ADDENDUM 3

DATE: November 18, 2016
PROJECT: MSB First Floor Infill LRC 3 & 4
RFP NO: 744-R1705
OWNER: The University of Texas Health Science Center at Houston
TO: Prospective Proposers

This Addendum forms part of and modifies Proposal Documents dated, October 19, 2016, with amendments and additions noted below.

Level 1 Floor Plan - East 1/4" = 1'-0" 2

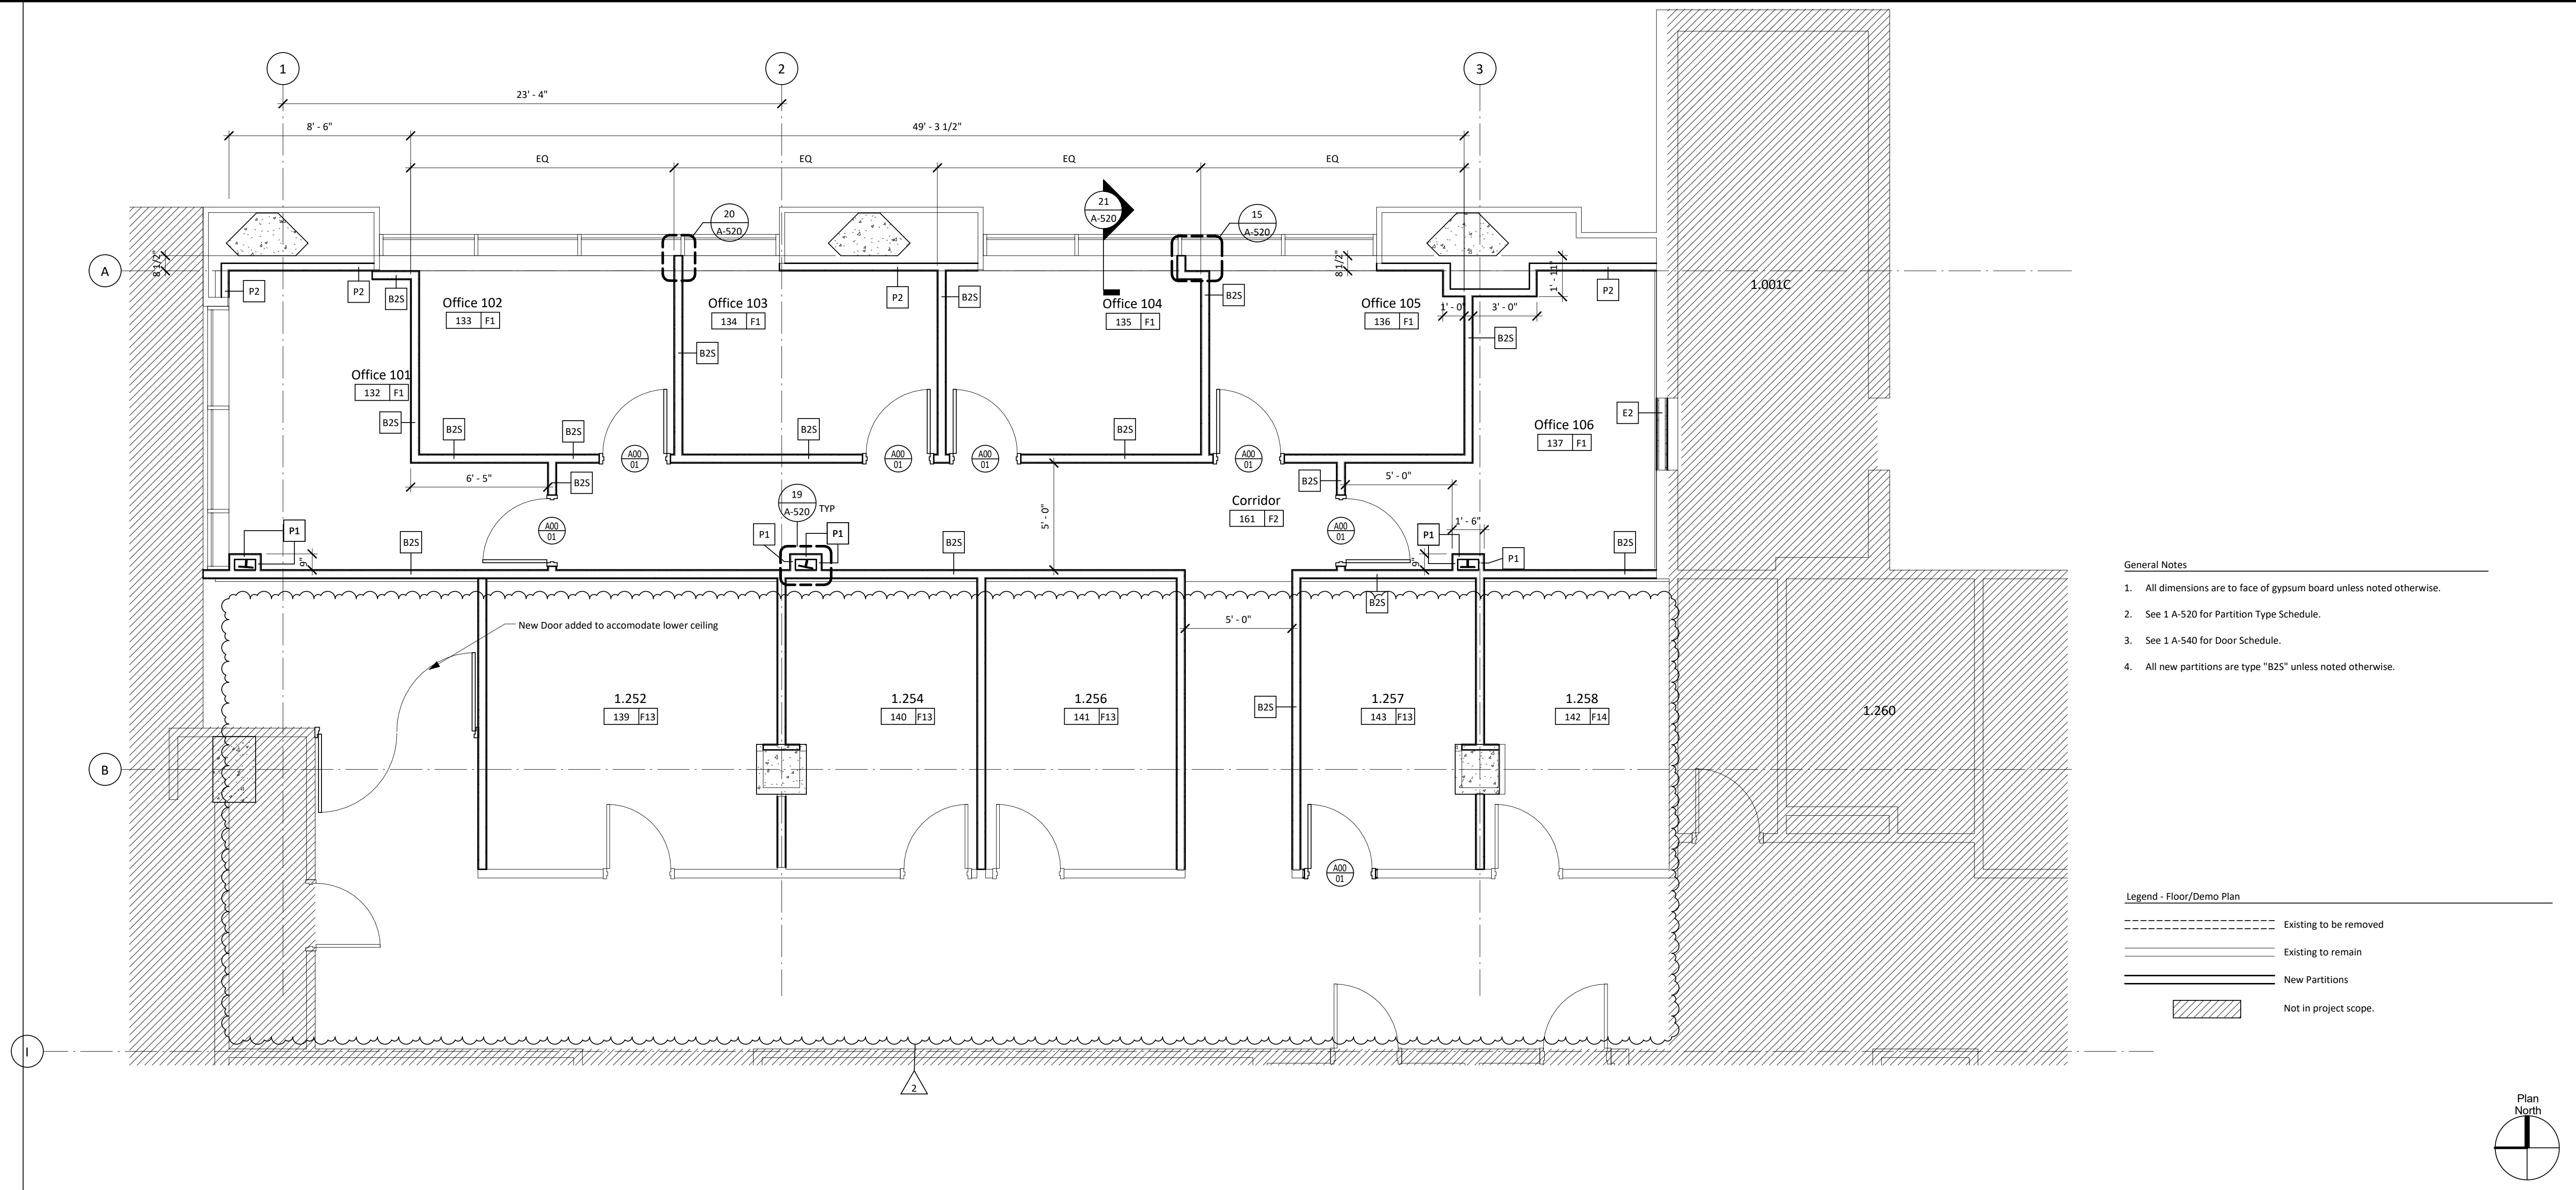
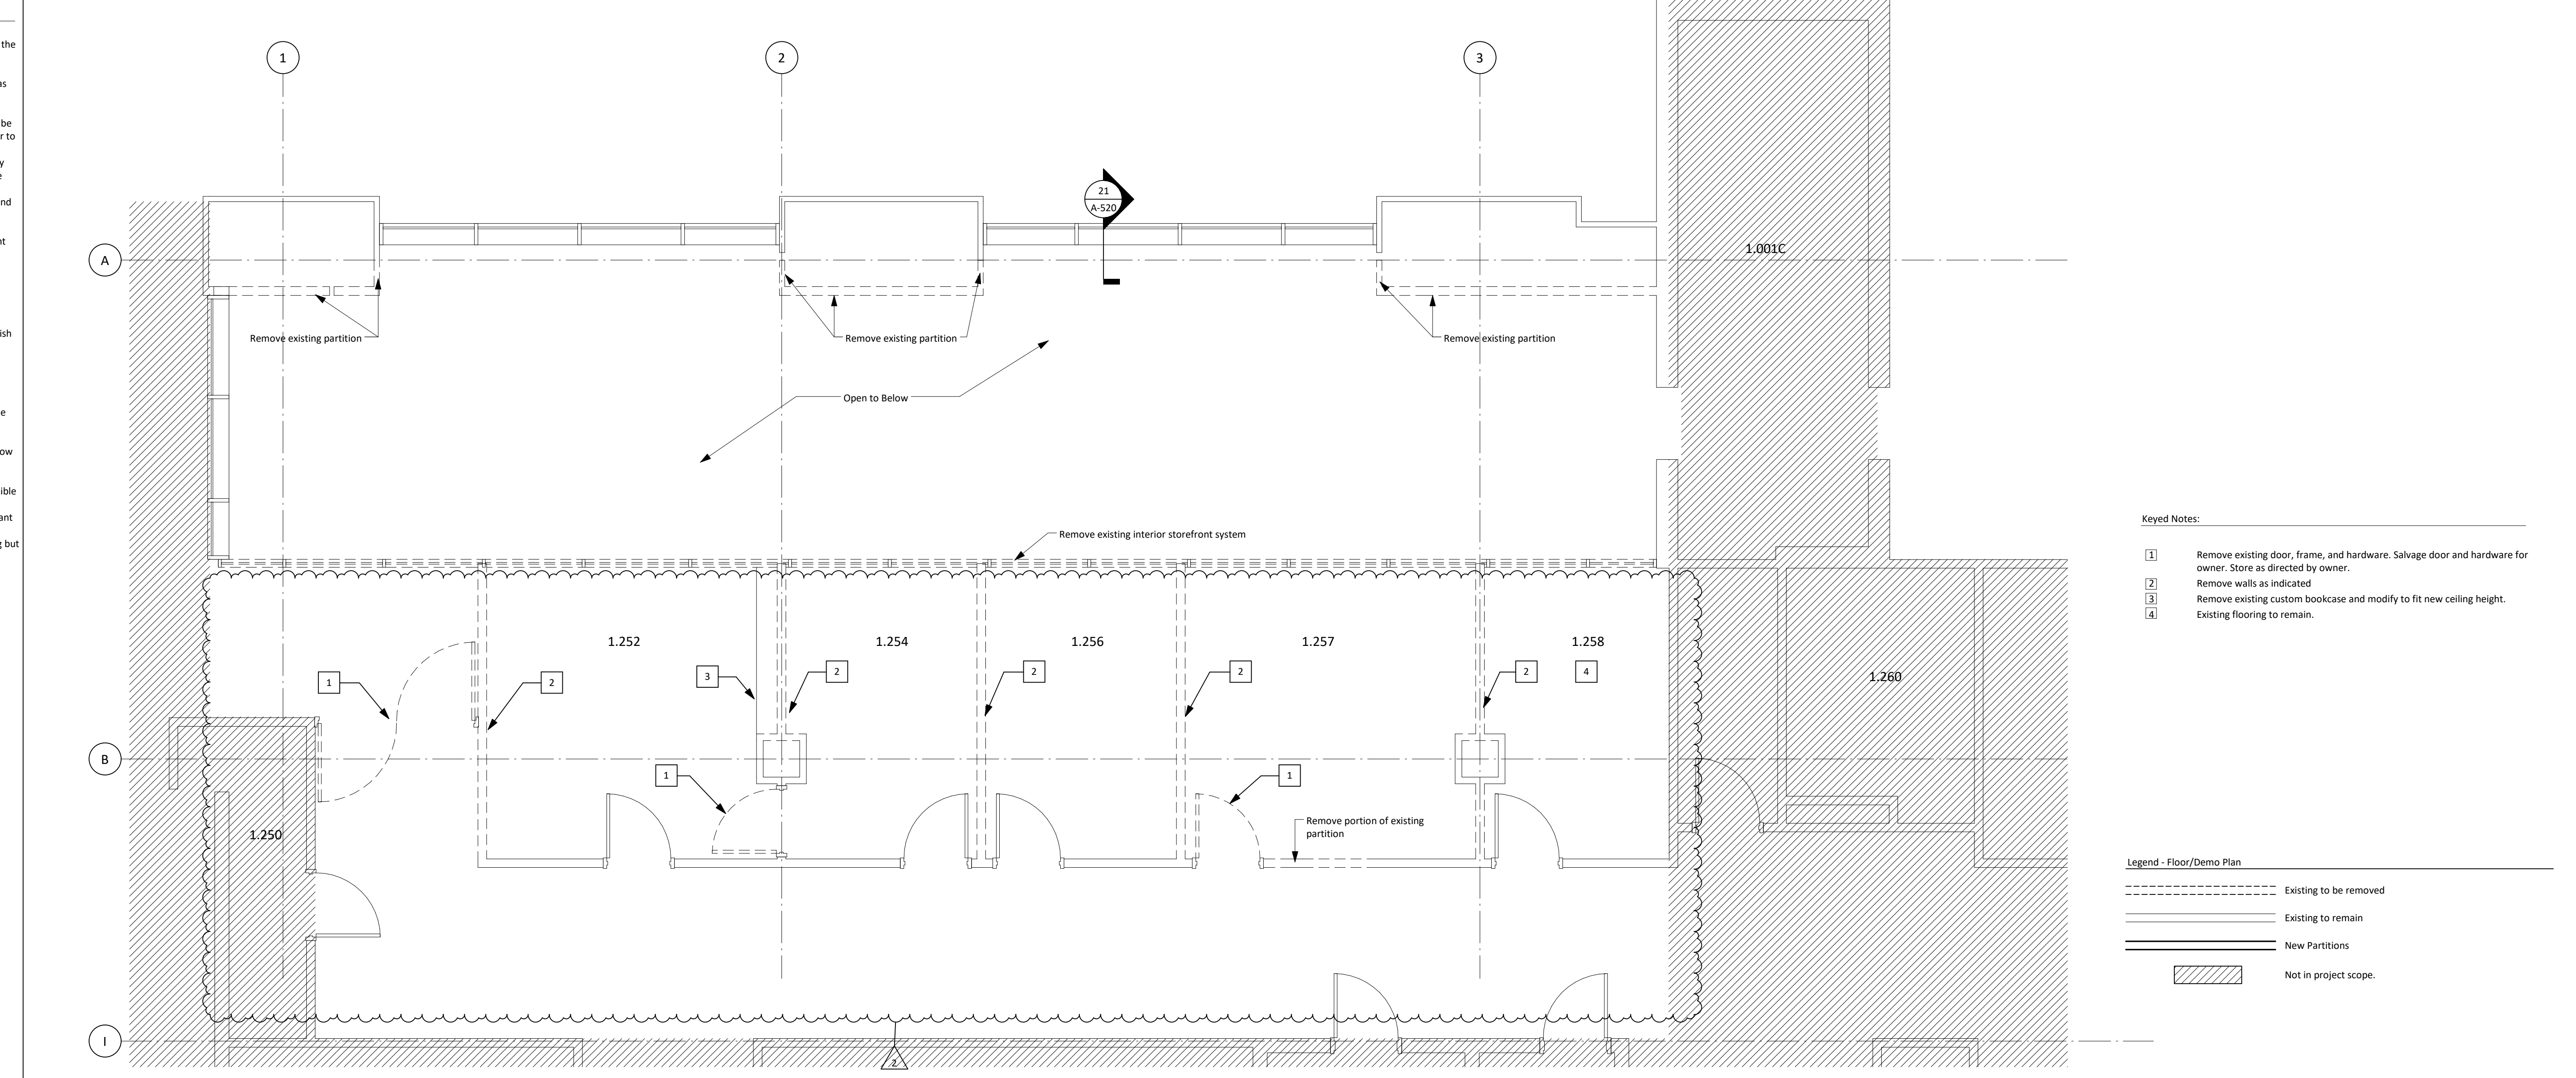
25. On drawing 2/A110 & 1/A111 - Please advise if fire rated shafts are to be built at the existing concrete columns along column line A (A110) and H (A-111). If so, please update partition type and provide details.
No fire rated shaft walls, fire safing to be installed between floors within existing shafts, detail to be provided in Addendum 3
